**August 12, 2016**  
**BOARD OF COUNTY COMMISSIONERS**  
**ORANGE COUNTY, FLORIDA**  
**IFB NO. Y17-701-CC/ ADDENDUM NO. 1**  
**REGIONAL COMPUTING CENTER A SIDE POWER FEED AND EMERGENCY**  
**GENERATOR REPLACEMENT**

**BID OPENING DATE: August 23, 2016**

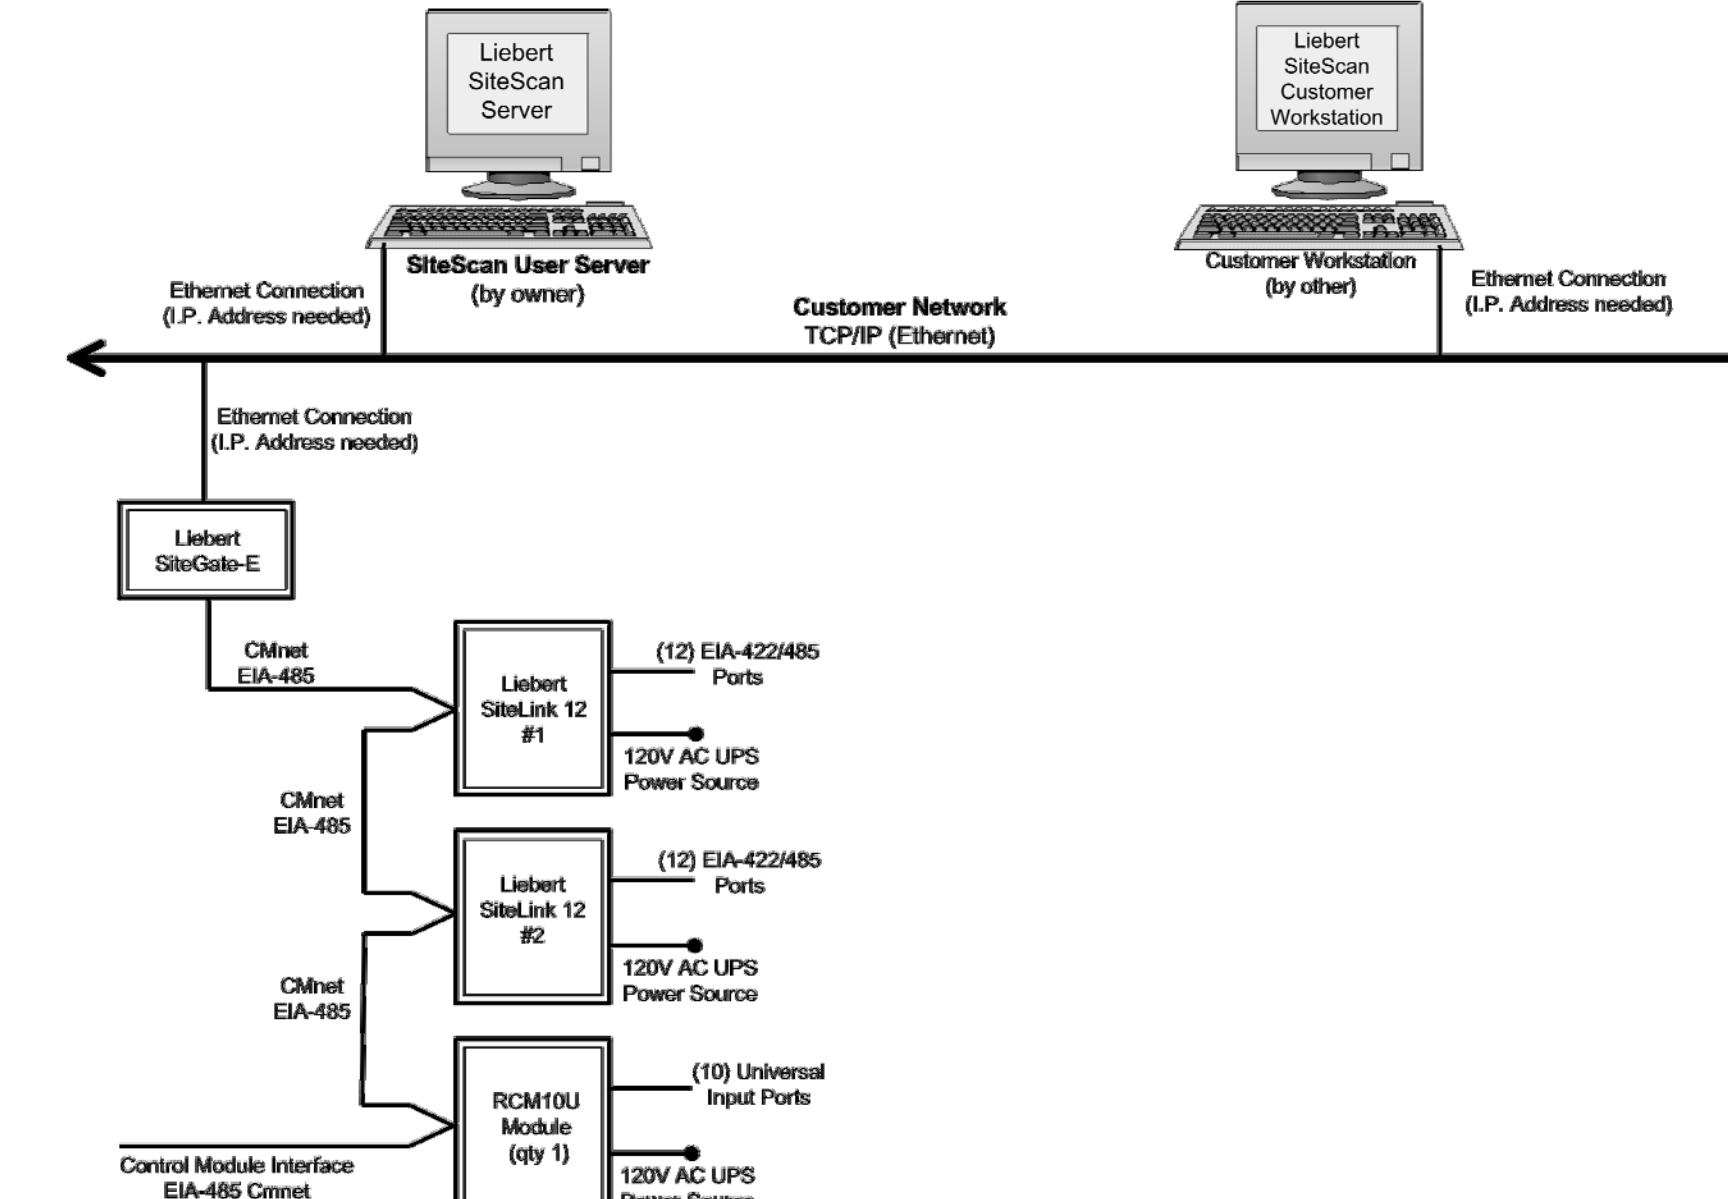
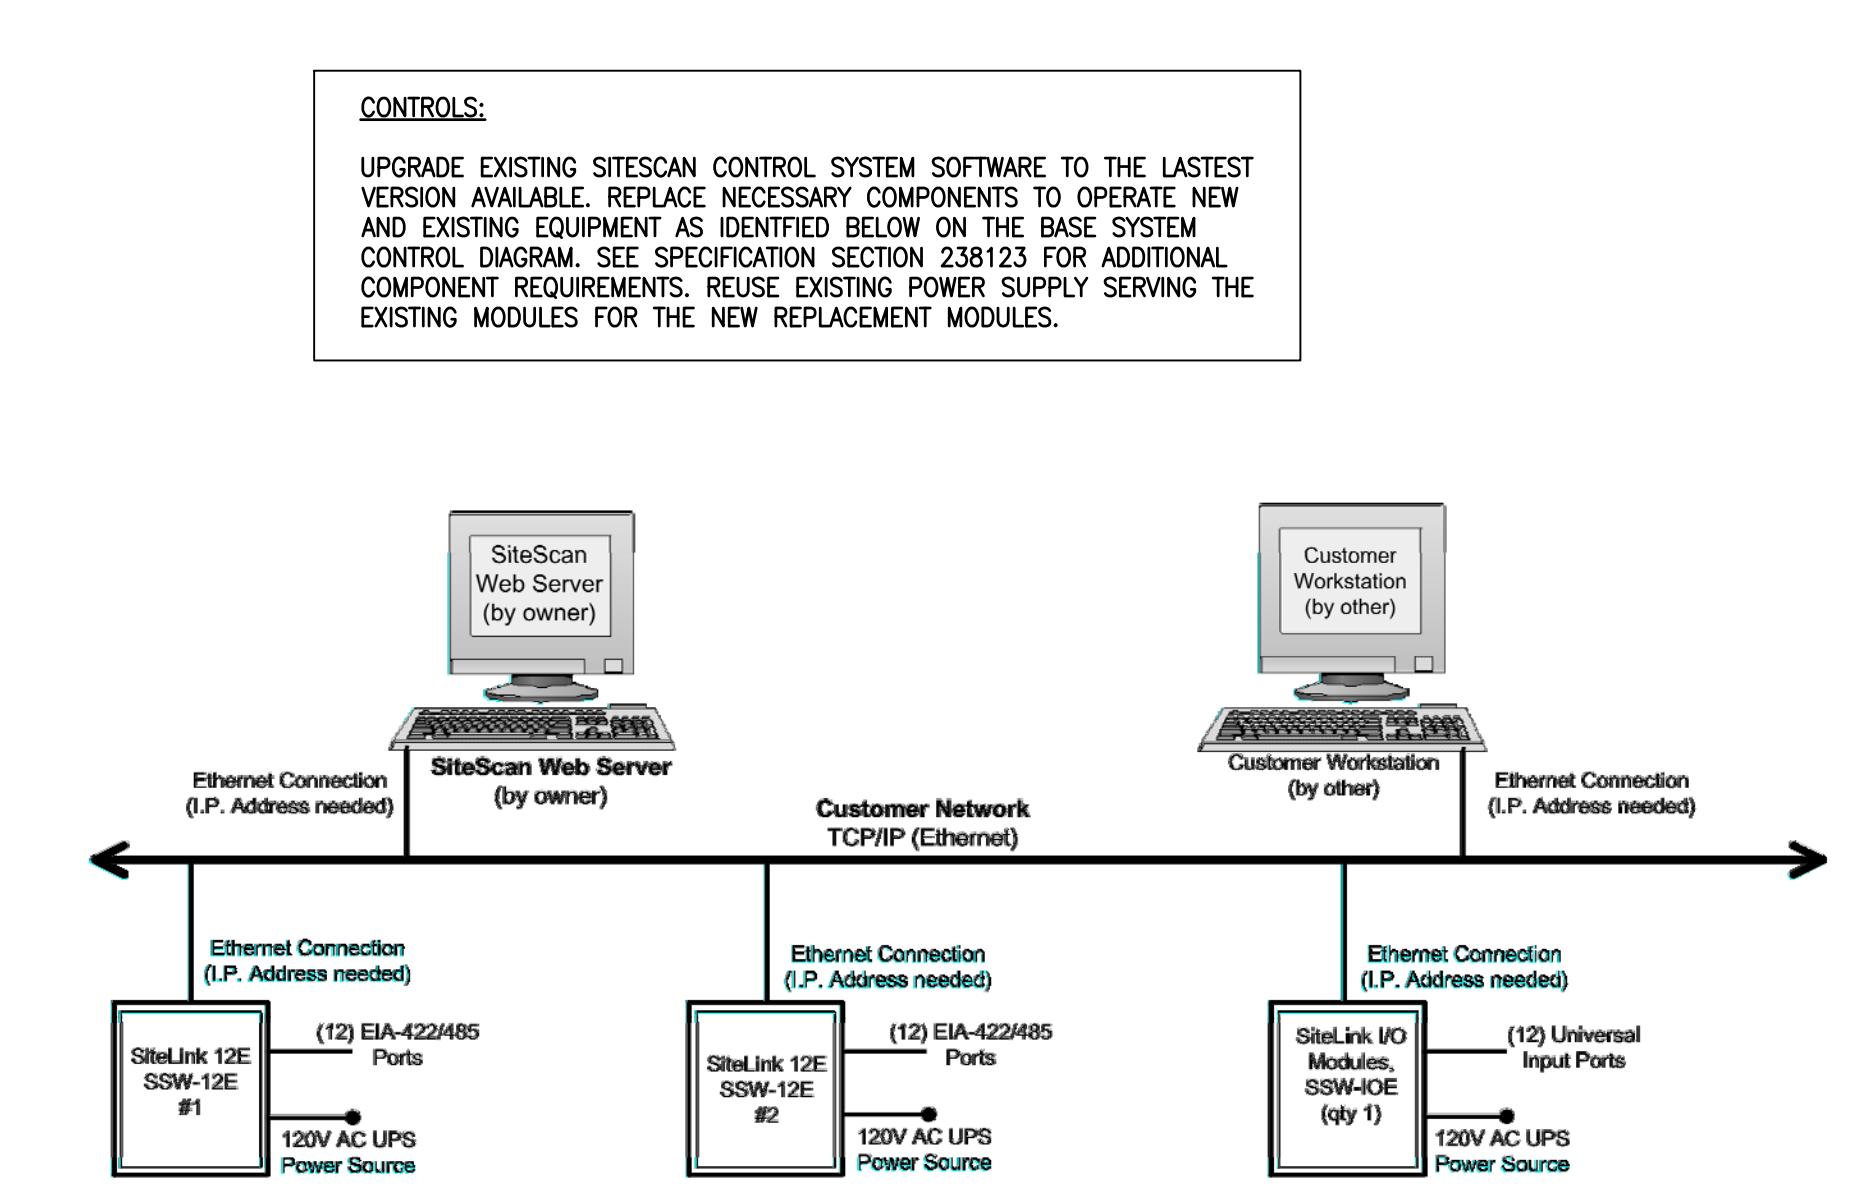
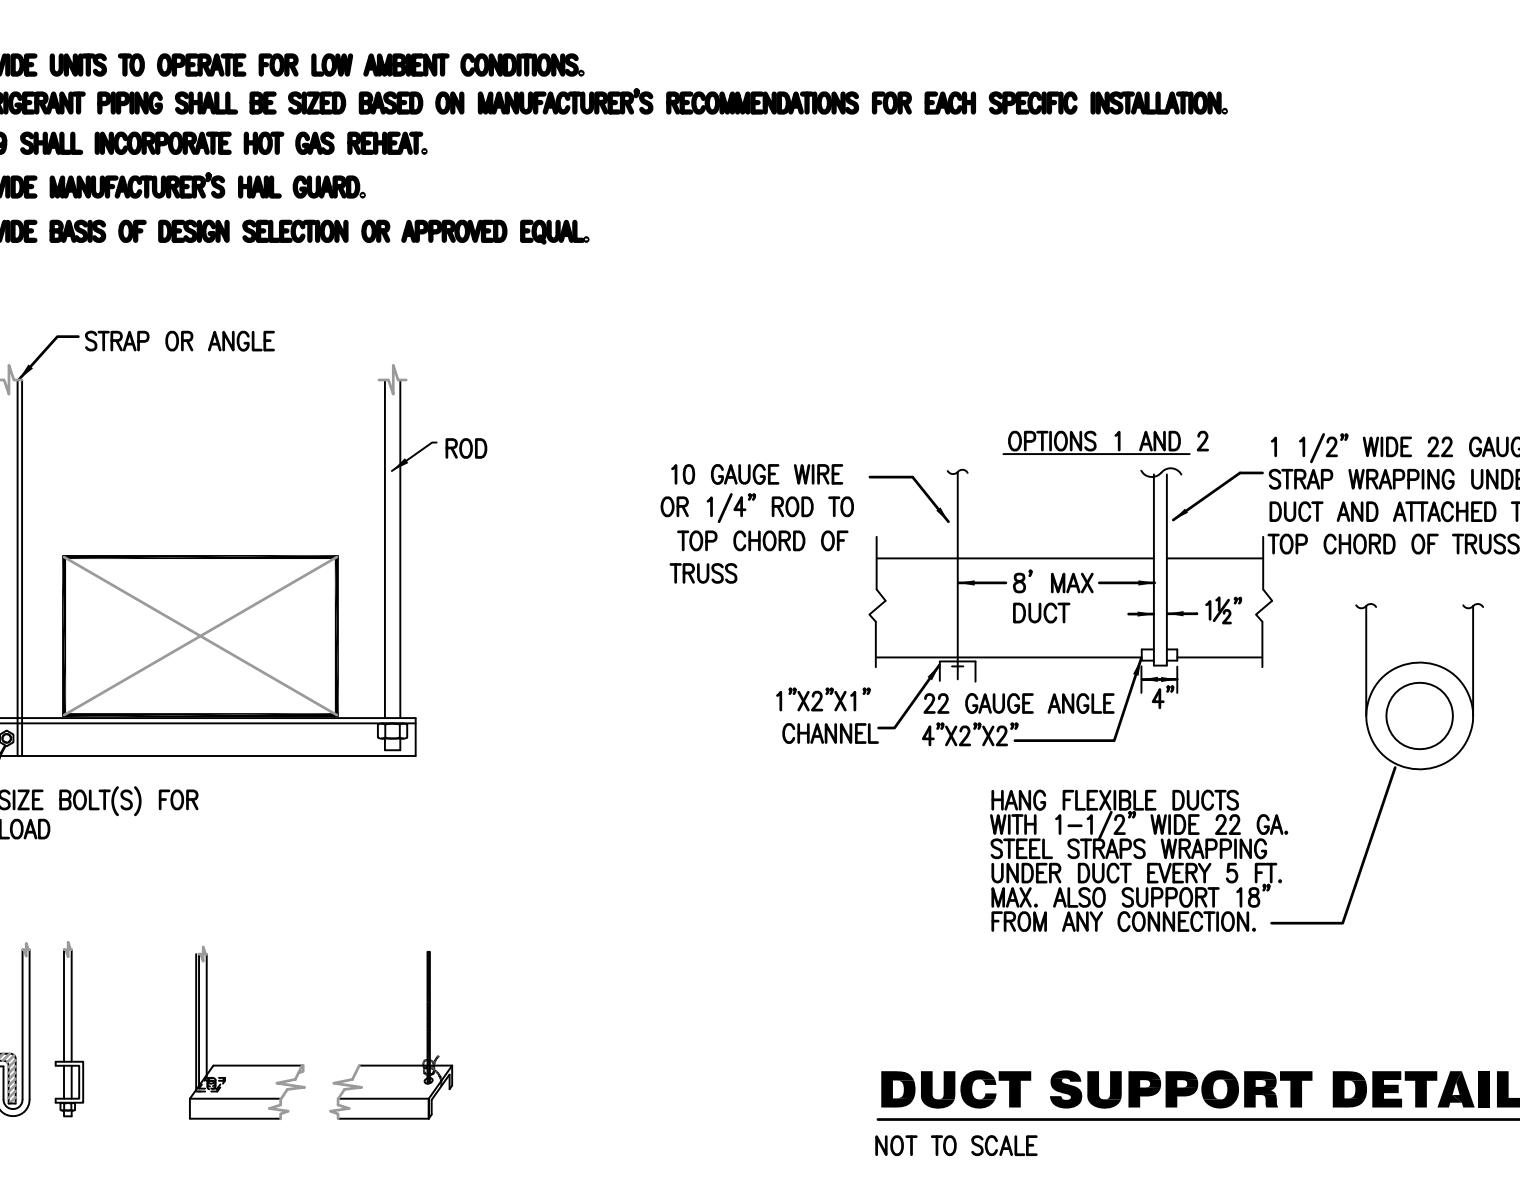
1. **Question:** Sheet ED2.1 hex note 4 directs us to provide spot coolers during the refeed of the CRAC units. Please advise the temperature levels and or BTU's to be maintained / provided.

**Answer:** Attached is the mechanical equipment schedule for existing CRAC units in which the spot coolers will have to match the heat load management.
